Return To Library > Records 2 > ERID-105000 Through ERID-105499 > ERID-105038 1) SUBMITTAL OF THE RESPONSE TO THE NOTICE OF DISAPPROVAL FOR THE INVESTIGATION WORK PLAN FOR UPPER CANADA DEL BUEY AGGREGATE AREA AND REVISION 1, 2) NOTICE OF DISAPPROVAL EPA ID NO NM0890010515, HWB-LANL-08-013, LA-UR-08-6121, EP2008-0507, 3) INVESTIGATION WORK PLAN FOR UPPER CANADA DEL BUEY AGGREGATE AREA, REVISION 1, LA-UR-08-6122, EP2008-0508, 4) MAP PLATE 1, 5) ATTACHED CD LA-UR-08-6122, EP2008-0508

Date: September 29, 2008
Refer To: EP2008-0507

Subject: Submittal of the Response to the Notice of Disapproval for the Investigation Work Plan for Upper Cañada del Buey Aggregate Area and Revision 1

Figure 5.6-2 Proposed sampling locations for SWMUs 46-003(e), 46-004(d), 46-004(e), and 46-008(f)

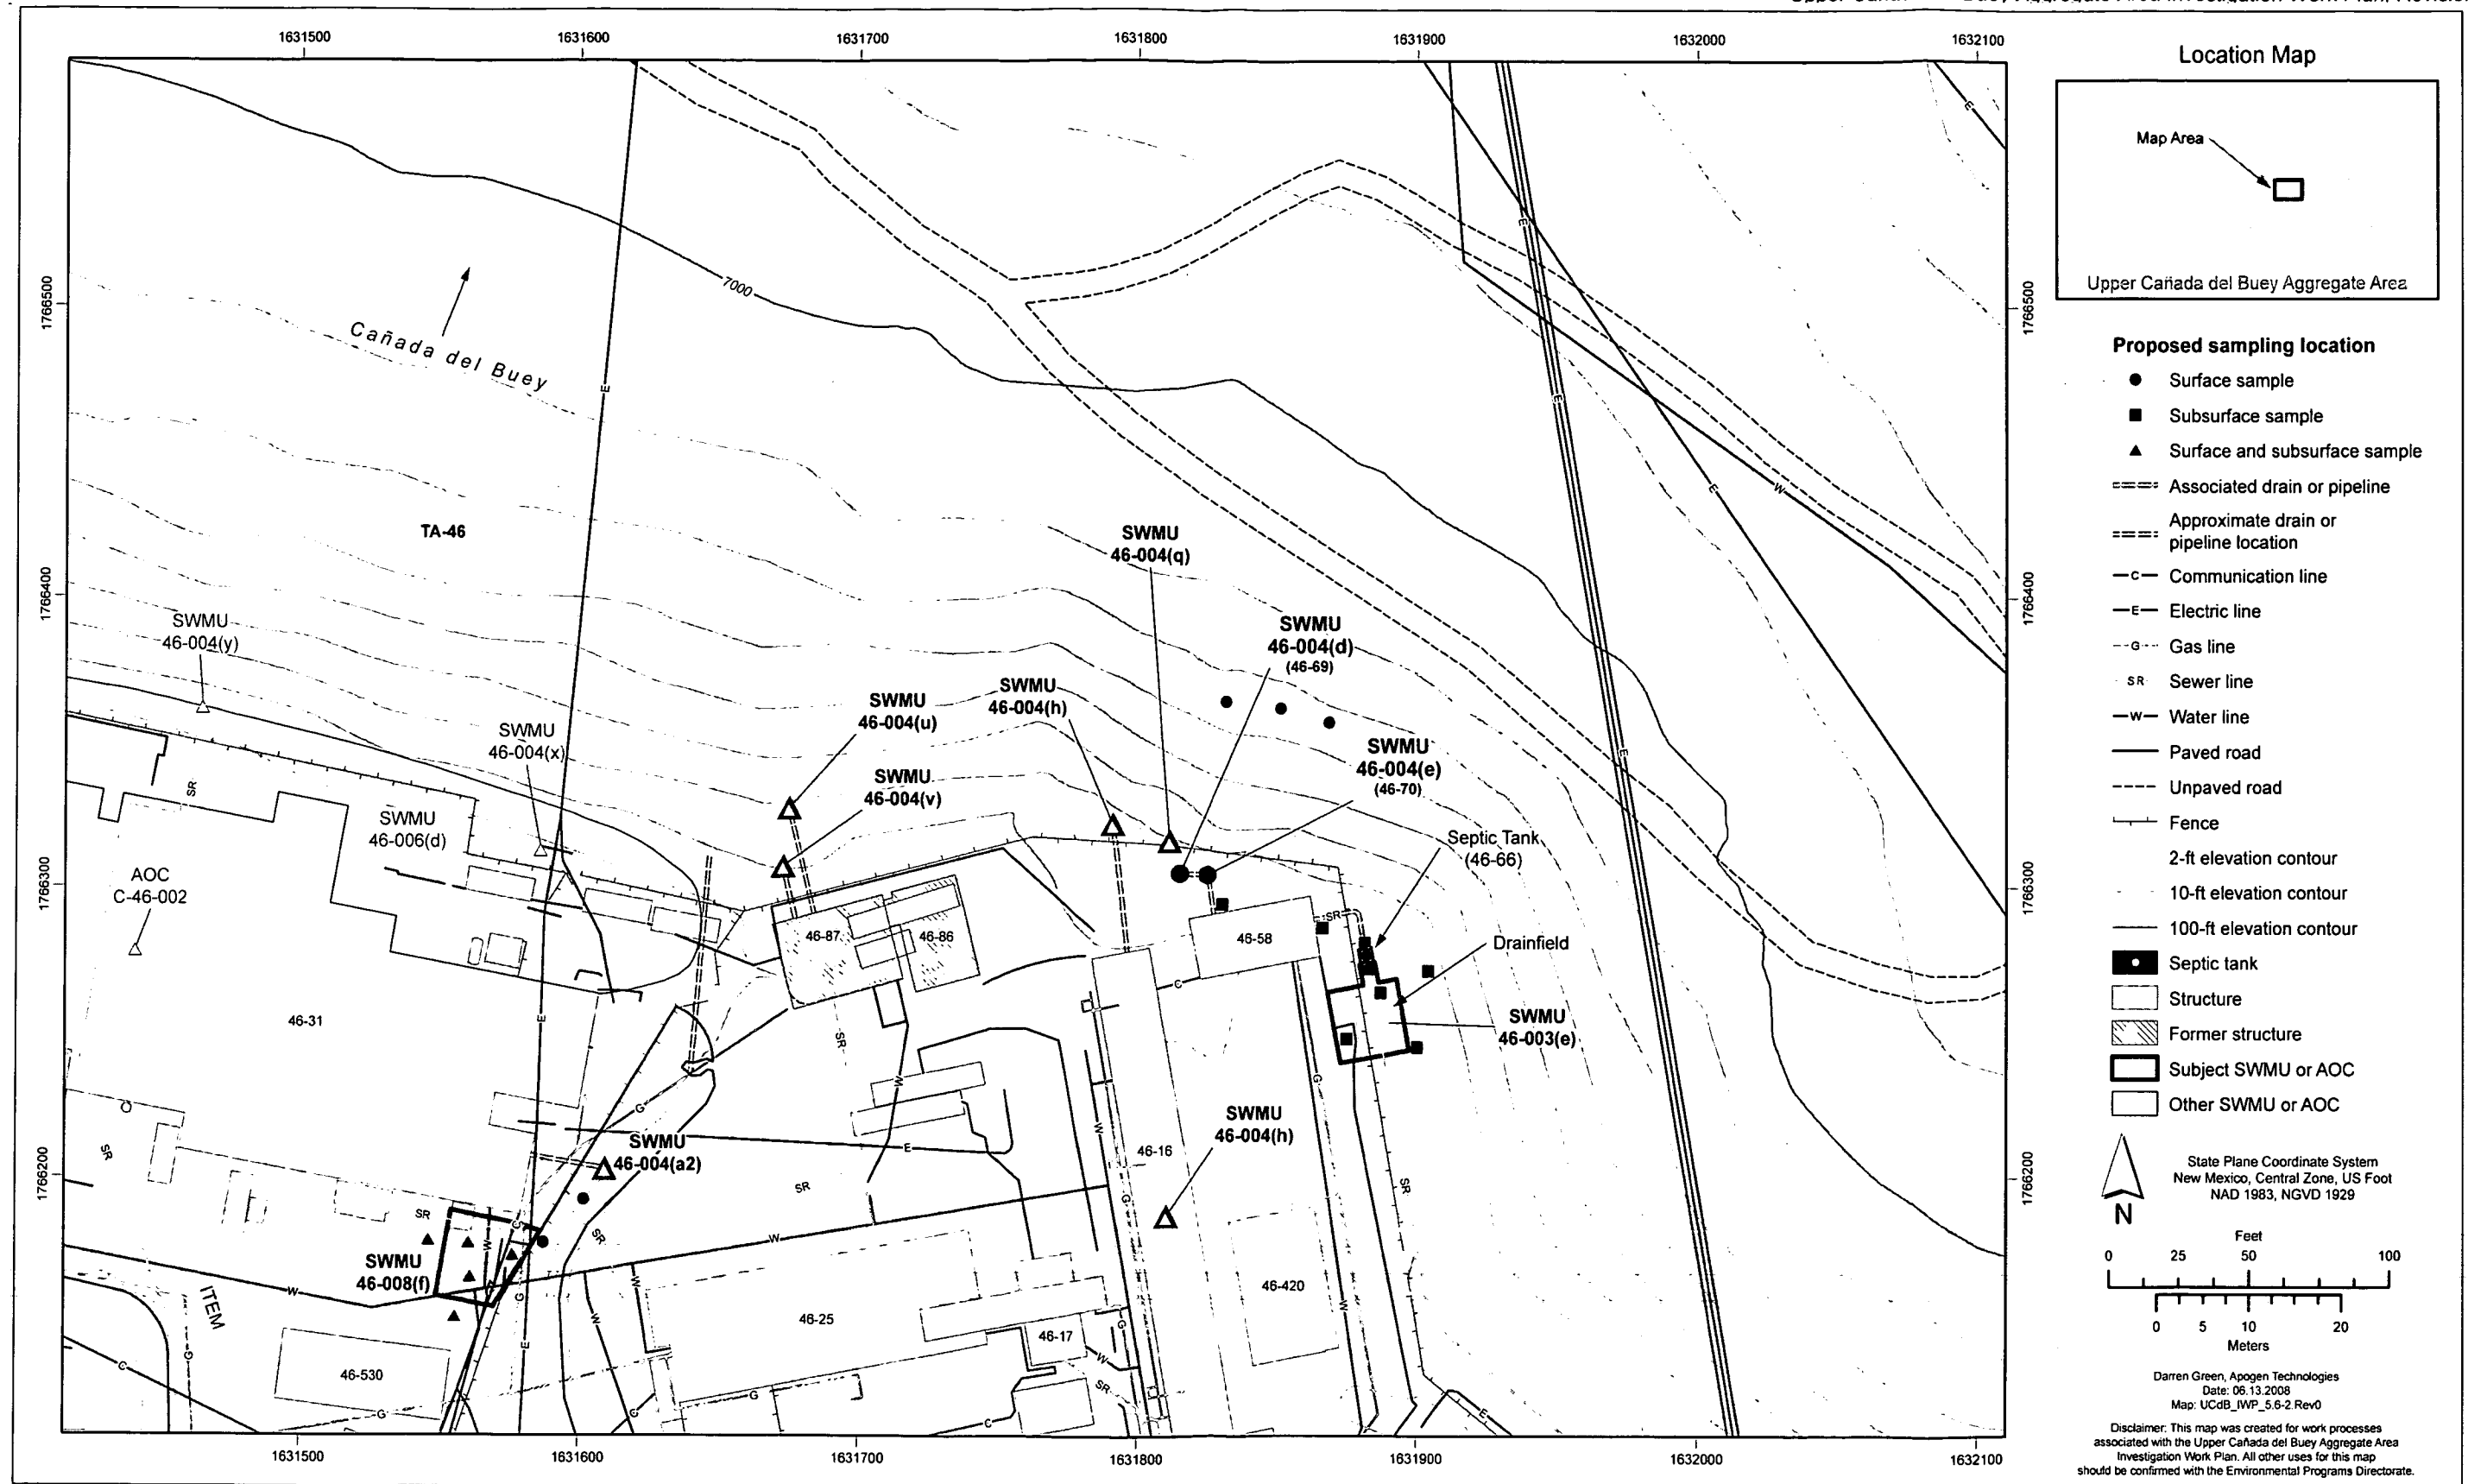
Permittees' Statement: "Eight samples will be collected from four locations associated with the location of the former distribution box and drain field (Figure 5.6-2)."

Permittees' Statements: "Twelve samples will be collected from three locations, one down the center of and two adjacent to the dry well (Figure 5.6-2)." and, "In the event of auger refusal because of the presence of gravel/cobbles in the bottom of the well, an alternative location/borehole will be drilled downgradient of the well."

Permittees' Statements: "Twelve samples will be collected from three locations, one down the center of and two adjacent to the dry well (Figure 5.6-2).", "Samples will be collected from four depths (at the base of the well, and 5 ft, 10 ft, and 15 ft below the well)..." and, "In the event of auger refusal because of the presence of gravel/cobbles in the bottom of the well, an alternative location/borehole will be drilled downgradient of the well."

2. Figure 5.6-2, the text in section 5.6.2, and Table 4.0-1 of the work plan have been revised to indicate that two additional samples will be collected from one location next to the area where the drainline exits building 46-58. The samples will be collected from the 0- to 1-ft interval directly beneath the drainline and from the 5- to 6-ft interval beneath the drainline and analyzed for TAL metals, volatile organic compounds (VOCs), semivolatile organic compounds (SVOCs), PCBs, nitrate, cyanide, perchlorate, isotopic uranium, isotopic plutonium, americium-241, and gamma spectroscopy.

6. In response to Specific Comments 6 and 7, Figure 5.6-2 and the text in sections 5.15.1.2 and 5.15.2.3 have been revised to show that three of the proposed sampling locations next to the dry wells have been moved to transect locations downslope of both dry wells. Table 4.0-1 has been revised to indicate that the samples from these new locations will be collected from two depth intervals (0 to 1 ft and 1 to 2 ft) and analyzed for the same analytical suite proposed for the other samples to be collected for SWMUs 46-004(d) and 46-004(e). The text in sections 5.15.1.2 and 5.15.2.3 has been revised to state that NMED will be consulted in the event auger refusal is encountered during sampling activities at the bottom of each dry well. In addition, the description of the dry wells has been revised to indicate that the base of each well is approximately 10 ft below ground surface (bgs).

7. See response to Specific Comment 6 above. Figure 5.6-2 and the text in section 5.15.2.3 have been revised to show the proposed sampling location southeast of the dry well has been moved to a location next to the concrete platform/loading dock attached to the north side of building 46-58. This sampling location is the closest point to the area where the inlet drainline to the SWMU 46-004(e) dry well exits building 46-58. Samples from this location will be collected from depth intervals of 0 to 1 ft and 2 to 3 ft beneath the drainline and analyzed for the same analytical suite proposed in Table 4.0-1.

Figure 5.8-2 Proposed sampling locations for SWMUs 46-003(g), 46-005, and 46-006(c)

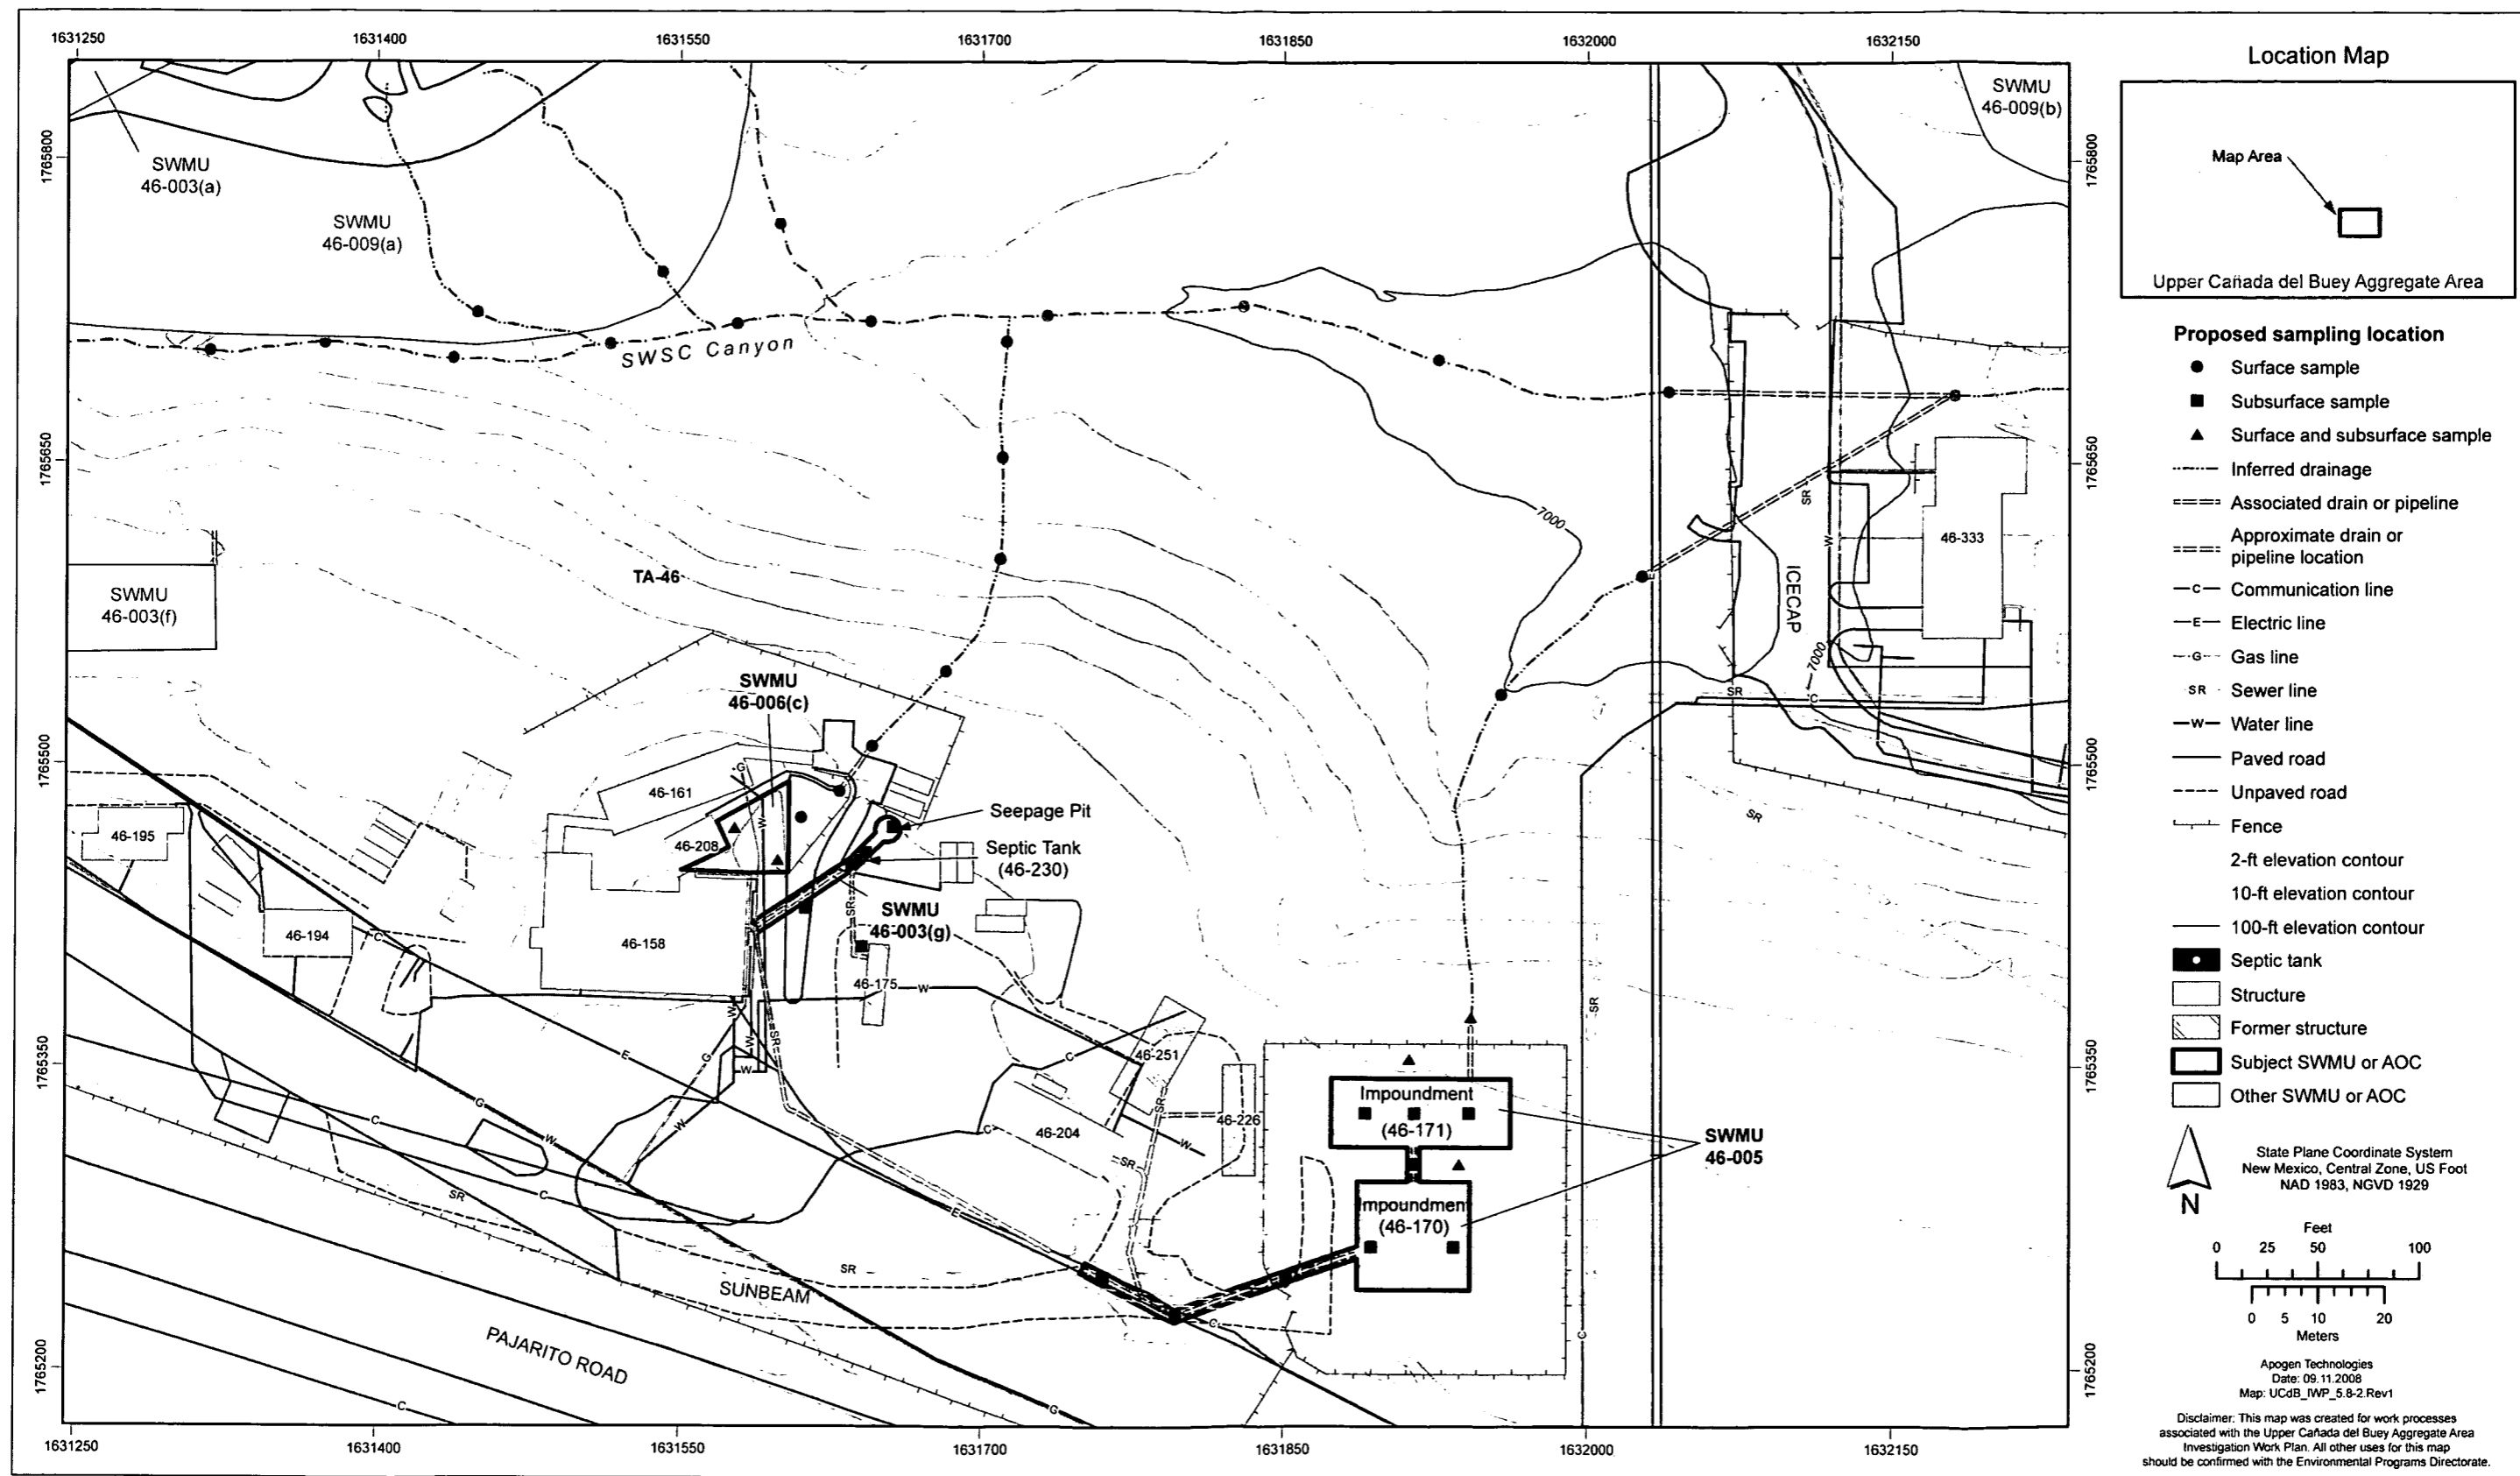
Permittees' Statements: "Two samples will be collected from one location below the tank (Figure 5.8-2)." and, "Four samples will also be collected from two locations beneath the primary and secondary inlet lines (Figure 5.8-2)."

Permittees' Statement: "Fourteen samples will be collected from seven locations within and next to the surface impoundments (Figure 5.8-2)."

4. The text in section 5.8.2 and Table 4.0-1 of the work plan have been revised to indicate that samples will be collected from two depth intervals at three sampling locations beneath the septic tank and the tank inlet and outlet to define the nature and extent of contamination. Figure 5.8-2 has been revised to show the new sampling locations and the proposed sampling location just north of former structure 46-175, now located approximately 20 ft to the south, next to the piping bend located a few feet west of former structure 46-175. The new samples will be collected from the same depth intervals and analyzed for the same constituents as the samples previously proposed for this SWMU.

10. Figure 5.8-2 of the work plan has been revised to show the proposed sampling location outside of and just east of the southern impoundment (structure 46-170) has been moved to a location south of the fence along the north side of the north impoundment (structure 46-171). In addition, one of the proposed sampling locations from the south impoundment has been moved to a location inside the northern impoundment, and the symbol for the sampling location next to the line connecting the two impoundments has been changed (from a circle to a triangle) to denote that surface and subsurface samples will be collected. In addition, section 5.32.2, Table 4.0-1, and Figure 5.8-2 have been revised to clarify sampling depths associated with the four locations beneath the drainlines.
